## **Central Planning Authority**

**Agenda** for a meeting of the Central Planning Authority to be held on February 03, 2021 at **10:00am, in Conference Room 1038, 1<sup>st</sup> Floor, Government Administration Building, Elgin Avenue.**

**CPA/03/21**

Figure 1: DOE's 2013 Habitat Map Extract showing application site outlined in blue

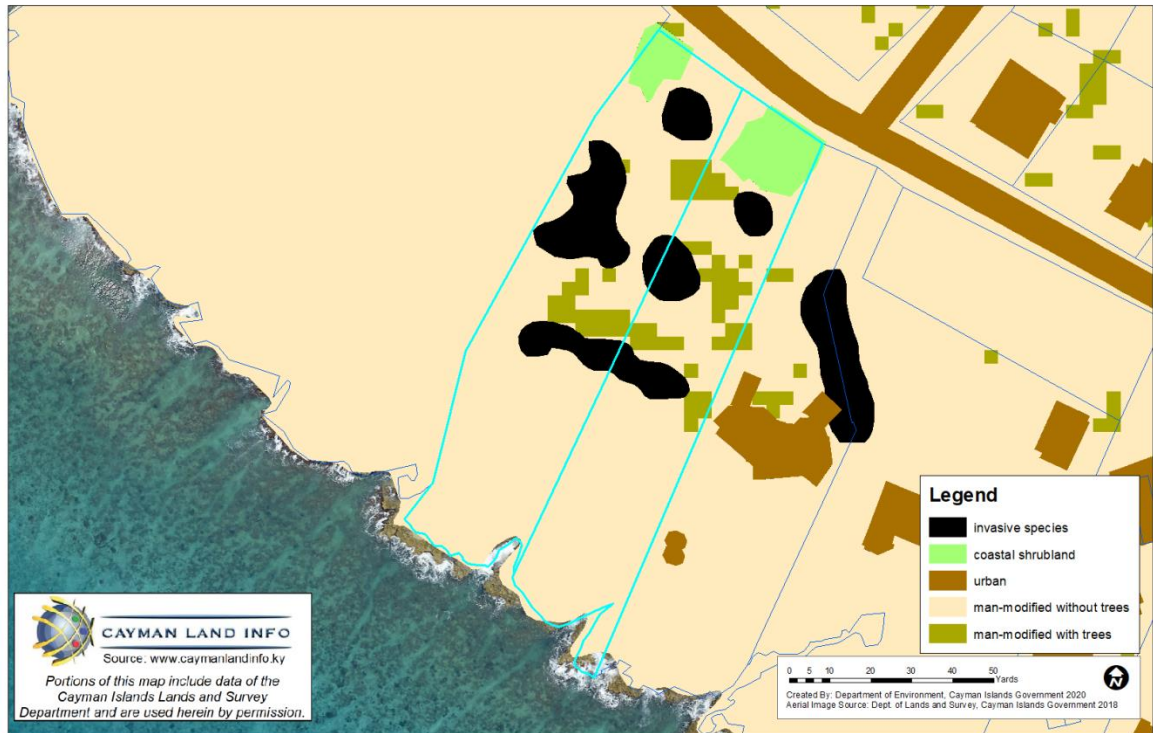
*The application site is man-modified with some primary coastal shrubland habitat in the northern section as shown in Figure 1. The site is also located adjacent to a marine protected area (a Marine Park) and is on a high wave energy coastline with deep water offshore. It is also noted that the site and the property immediately to the west have a*

Figure 2: LIS 2018 Aerial Imagery showing geological feature (circled in red) and the application site (outlined in blue). Source: Cayman Land Info

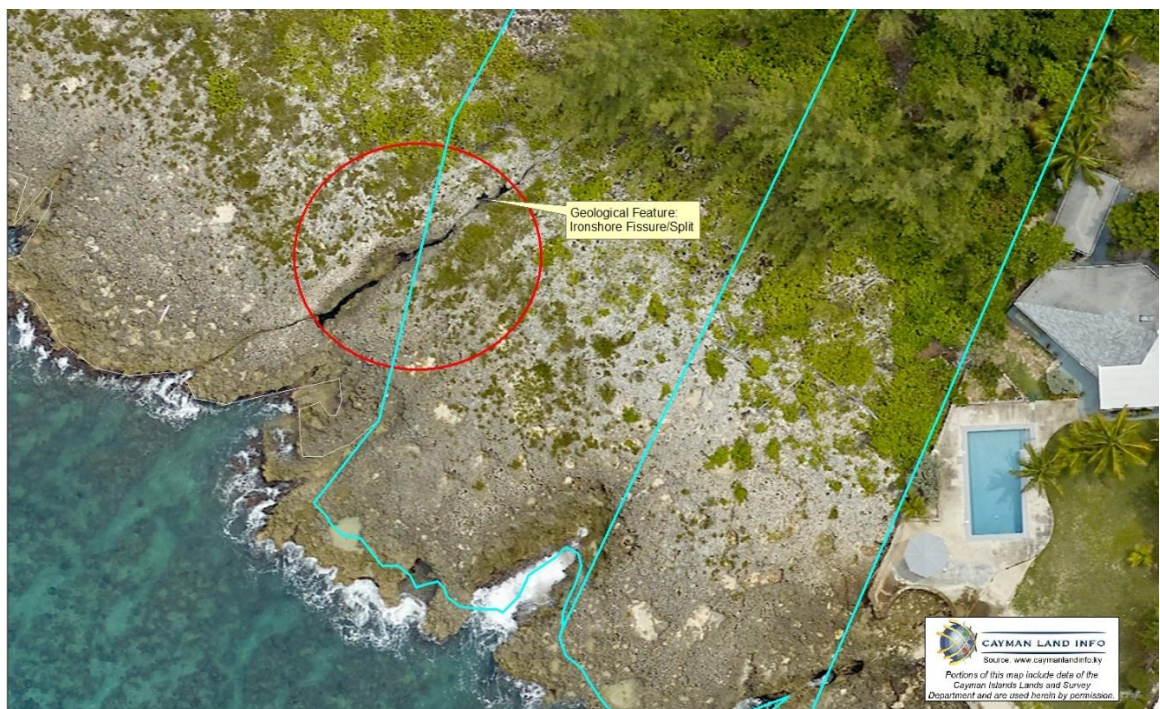
unique geological feature in the form of a split/fissure in the ironshore, as shown in figure 2

*Figure 4: Extract of submitted plans overlaid on LIS 2018 aerial imagery showing the proximity of the split/fissure to the western proposed dwelling (Source: Declan O'Brien Architectural Services & Cayman Land Info)*

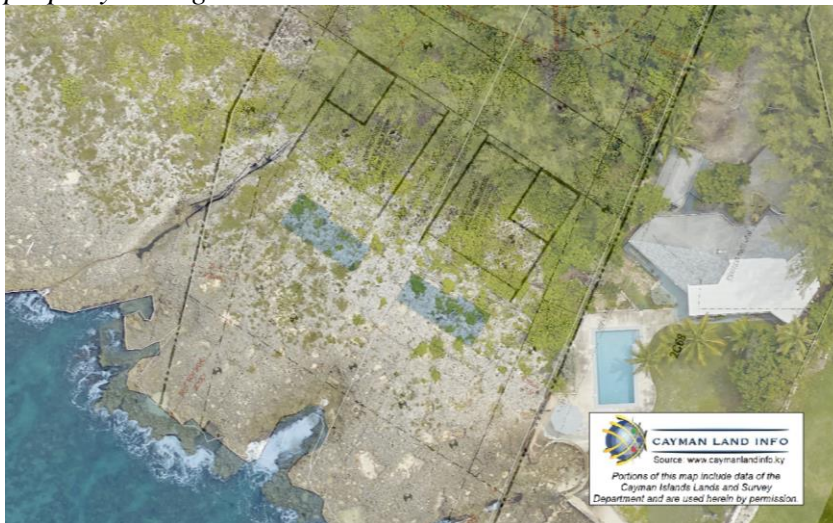
*The western single family home is extremely close to the ironshore split/fissure, and the DoE will not support any future filling of or works to the split as it is directly connected to the sea and Marine Park. The DoE would urge the applicant to seek advice from a structural engineer to ensure that the split/fissure does not cause a threat to the structural integrity of the property. The home could also be impacted as the split/fissure is directly connected the sea, and could potentially bring storm waves closer to the property during inclement weather.*

*Therefore, if the CPA is minded to grant planning approval, under Section 41(5)(a) of the National Conservation Law, the National Conservation Council **respectfully directs** the Central Planning Authority to include the below as conditions of approval:*

**Figure 2: Elevation model showing the South Sound drainage basin (outlined in red) and the approximate location of the application site within the blue outline.**

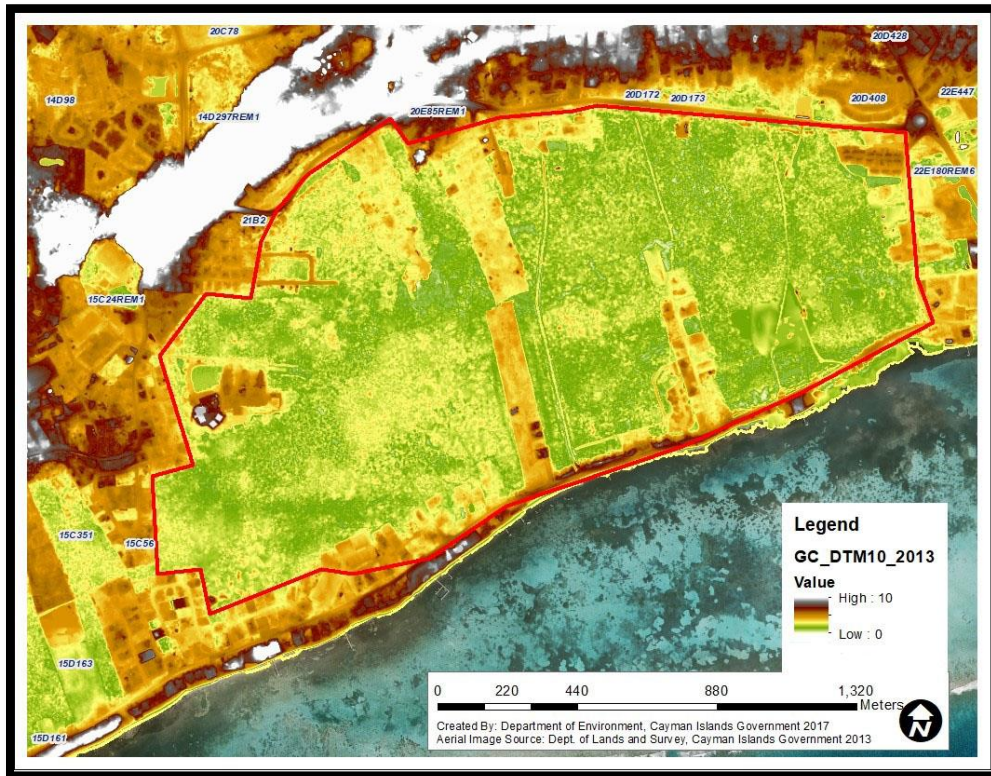
*The subject parcel of mangrove habitat is located within the South Sound drainage basin (see Figures 1 & 2). The South Sound basin functions as a water catchment and storage basin which provides flood controls and storm-water retention. Surface water is stored in the wetlands, which provides a natural mechanism for reducing flow velocity and flooding. This basin also contributes to the maintenance of water quality in the South Sound Lagoon. Unfortunately, the South Sound drainage basin has become severely fragmented by current and future developments impacting the overall capacity of the remaining wetland area to accommodate drainage for the whole basin.*

*The DoE has consistently raised concerns about the lack of a comprehensive stormwater management strategy for the South Sound drainage basin over the years. As outlined in the attached Memo dated 30 January 2015 (5 years ago) from the DoE, Water Authority and National Roads Authority, to the Ministry of PLAHI, there are significant concerns regarding the development of this area without an adequate comprehensive stormwater management strategy. The specific recommendation of the Memo was “to issue an RFP to select a suitably qualified consultant to undertake a hydrological assessment of the South Sound drainage basin and devise a regional stormwater management plan, which will include drainage engineering specifications for the proposed road and future development and Best Management Practices to minimise the impacts of stormwater flooding”.*
